Access Compliance Report

Public Rights-of-Way

(Curb Ramps)

Intersection ID: 14871	Main Street: DRIFTWOOD_DR	Cross Street: WINTERFIELD_PL	Location: NE
ADA ID: 7B662CA46D1A	Ramp Type: PerpDiag	Initial Pass/Fail: Fail	Overall Compliance: No
Codes/Mitigation Info/Possible Solution			Severity Score: 10
			Field Measurements/Component Compliance

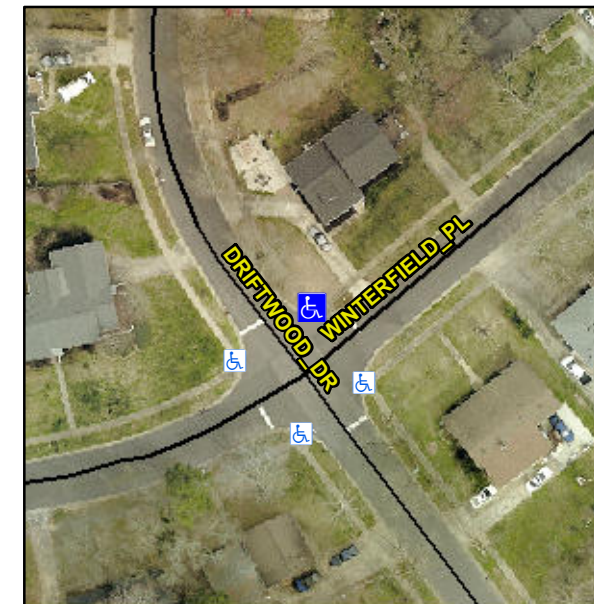
Not Found, R304.5.1, R304.5.3

Compliance	Description	Data	Compliance	Description	Data
N/A	Ramp Length (in)	62.0	Yes	Ramp Slope (%)	5.2
No	Ramp Width (in)	47.5	No	Ramp XSlope (%)	4.7
N/A	Flare Type LT	N/A	N/A	Flare Type RT	N/A
N/A	Flare Slope LT (%)	N/A	N/A	Flare Slope RT (%)	N/A
N/A	Flare Traversable LT?	N/A	N/A	Flare Traversable RT?	N/A
N/A	Landing Length (in)	N/A	N/A	DWS Provided?	N/A
N/A	Landing Width (in)	N/A	N/A	DWS Contrast?	N/A
N/A	Landing Slope (%)	N/A	N/A	DWS Length (in)	N/A
N/A	Landing X Slope (%)	N/A	N/A	DWS Full Width?	N/A
N/A	Landing Curb? (Y/N)	N/A	N/A	DWS Offset (in)	N/A
N/A	Shared Landing?	N/A			
N/A	Gutter Ponding?	N/A	N/A	Gutter Slope (%)	N/A
N/A	Gutter Lip Ht (in)	N/A	N/A	Gutter X Slope (%)	N/A
N/A	Painted X Walk1?	No	N/A	Painted X Walk2?	No
	X Walk 1 Direction	To SW		X Walk 2 Direction	To SE
N/A	X Walk 1 Width (in)	N/A	N/A	X Walk 2 Width (in)	N/A
	X Walk 1 Slope (%)	5.0		X Walk 2 Slope (%)	0.2
	X Walk 1 X Slope (%)	2.0		X Walk 2 X Slope (%)	3.1

N/A	Ramp inside XWalk1?	N/A	N/A	Ramp inside XWalk2?	N/A
	Road Slope (%)	3.7	N/A	Clear Space?	N/A
	Road X Slope (%)	1.7	N/A	Clear Space to XWalk (in)	N/A
N/A	Any Obstructions?	N/A	N/A	Storm Grate/Utility Hazard?	N/A
	Obstruction Type			Storm Grate/Utility Type	
		N/A			N/A
			Yes	Surface Condition? (G/P)	Good

Remove & Replace Curb Ramp With Two New Directional Ramps or Equivalent.

Total Cost: \$ 3200.00
